HIROSE ELECTRIC CO., LTD.
2-6-3 Nakagawa Chuoh, Tsuzuki-ku, Yokohama, JAPAN

UX60SC Series Packaging Specification Change

■Product list PCN2025-05-2_UX60SC Series Packaging Specification Change

■ Reel material change (from paper to plastic)

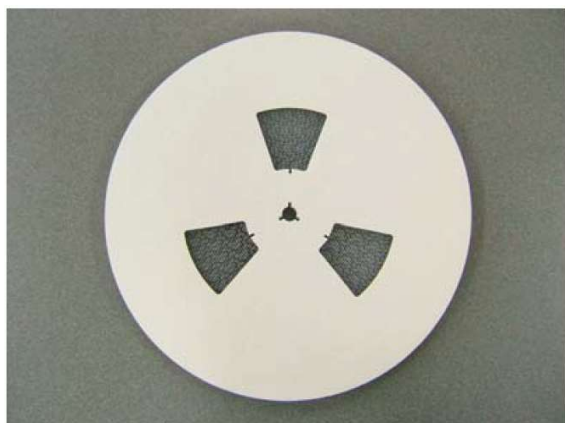
1	Products	UX series *Please refer to the attachment 1 for detailed product names.
2	Substitute proposal product	UX series *Please refer to the attachment 1 for detailed product names.
3	Classification of change	Packaging specification change.
4	Changes	We will change the embossing depth and the reel material (from paper to plastic). For details, please refer to Attachment 2.
5	Reason for change	<p>■Embossing Depth Change To prevent the adhesive tape from sticking to the cover tape and causing the product to pop out, we will change the embossing height. This is to improve the product's retention and enhance the implementation process for our customers.</p> <p>■Reel material change By changing the material from paper to plastic, we aim to eliminate fiber fragments from the paper, thereby ensuring a cleaner assembly process for our connectors and a cleaner implementation process for your connectors.</p>

Photo 1. Paper reels

Photo 2. Plastic reels
